# **CAP Meeting Agenda**

# ITEM 4.1 DEVELOPMENT APPLICATION - 24034447 – 11 & 11A CREMORNE STREET, FULLARTON

DEVELOPMENT NO.:	24034447
APPLICANT:	Changhui Wu
ADDRESS:	11A CREMORNE ST FULLARTON SA 5063 11 CREMORNE ST FULLARTON SA 5063
NATURE OF DEVELOPMENT:	Demolition of one semi-detached dwelling, alterations to the party wall and roof and change in dwelling type to detached dwelling, and construction of a double storey detached dwelling and front fence.
ZONING INFORMATION:	
	Zones: Established Neighbourhood Overlays: Airport Building Heights (Regulated) Co-located Housing Historic Area Prescribed Wells Area Regulated and Significant Tree Stormwater Management Urban Tree Canopy Technical Numeric Variations (TNVs): Maximum Building Height (Metres) (Maximum building height is 6m) Minimum Frontage (Minimum frontage for a detached dwelling is 16m) Minimum Site Area (Minimum site area for a detached dwelling is 700 sqm) Maximum Building Height (Levels) (Maximum building height is 1 level) Minimum Side Boundary Setback (Minimum side boundary setback is 1m for the first building level; 3m for any second building level or higher) Site Coverage (Maximum site coverage is 50 per cent)

# Pictures of the Window on the proposed plan compared to the other existing new buildings in the similar neighbourhood

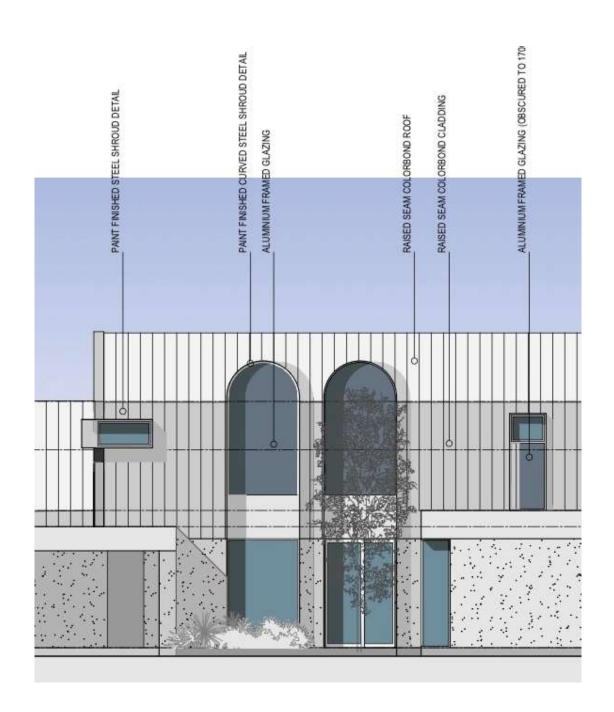
The planned window on the second floor is large, elevated, and positioned very close to our shared boundary, making it a direct intrusion into the privacy of our property. While the window may not be transparent, the sheer size and positioning of it, so near our living areas, create an overwhelming sense of exposure and loss of privacy. It will significantly alter the enjoyment of my home and the sense of personal space that my family and I currently have.

The planned window on the second floor is large, elevated, and positioned very close to our shared boundary, making it a direct intrusion into the privacy of our property. While the window may not be transparent, the sheer size and positioning of it, so near our living areas, create an overwhelming sense of exposure and loss of privacy. It will significantly alter the enjoyment of my home and the sense of personal space that my family and I currently have. Please find the pictures below in comparison.

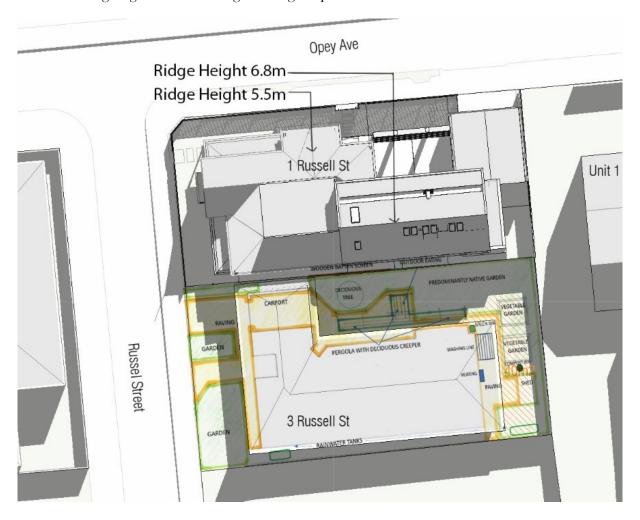
The Proposed Development substantially exceeds the maximum site coverage. I presume that this might be even more than is shown on the Site Coverage and Soft Landscaping Plan, which appears to understate site coverage by not including Veranda 1 and Veranda 3 (possibly also the area under the two second story balconies?).

The building footprint does exceed the 50% site coverage recommendation by 10%, however, it remains consistent with the surrounding neighborhood, where other developments also exceed this coverage. For reference, please see the following nearby properties: 5 Russell Street (80%), 53 Opey Avenue (70%), and 55 Opey Avenue (60%).

Verandahs 1 and 3 do not have a roof cover; instead, these areas are pergola structures that allow sunlight to pass through. Please note that we have updated the labelling in these areas to "Terraces," which more accurately reflects their nature and conveys the intended design intent.

### 6. PO 9.1 Rear Boundary Setback

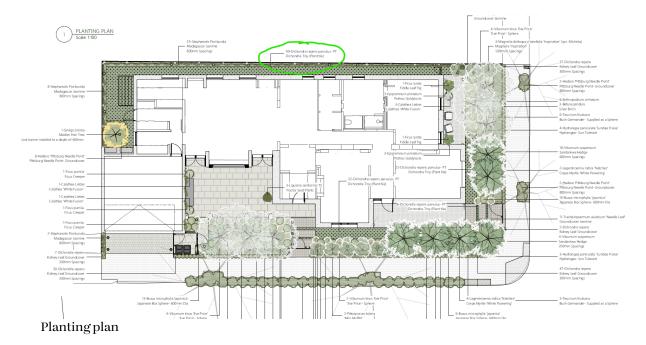
The Proposed Development does not adhere to the rear boundary setbacks and this has serious negative implications for the property at 3 Russell Street. Of the two standard setbacks for the rear boundary, the 6 metres for the second level is the more critical, given the shading it imposes on the outdoor area as well as the house at 3 Russell Street. However, sticking with the standard 4 metre setback for the first level would also be desirable with respect to natural light and ventilation and landscaping/vegetation and separation between buildings that complements the established character of the area.

We understand the concerns regarding overshadowing, ventilation, and landscaping. As mentioned above, overshadowing of the private open space and windows on the façade has been minimised and remains within the requirements. Please refer to pages 14 and 15 of the presentation for further details. Furthermore, we have reduced the roof slope and height to further minimise the impact on 3 Russell Street.

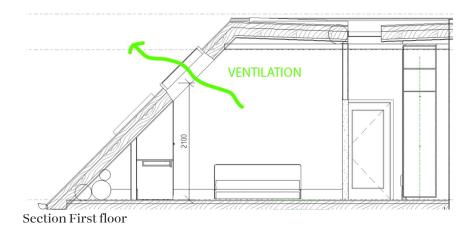
allow direct overlooking into the living area and main bedroom of 3 Russell Street. (As skylights, presumably they would be better placed on the northern side of the rear extension roof).

The skylights will be positioned at a height above the first-floor finished level that prevents any possibility of overlooking into 3 Russell Street. Skylights on the northern roof pitch can create an undesirable environmental effect by allowing excessive solar gain. Pitched roof skylights also provide the opportunity for ventilation, which flat roof skylights do not.
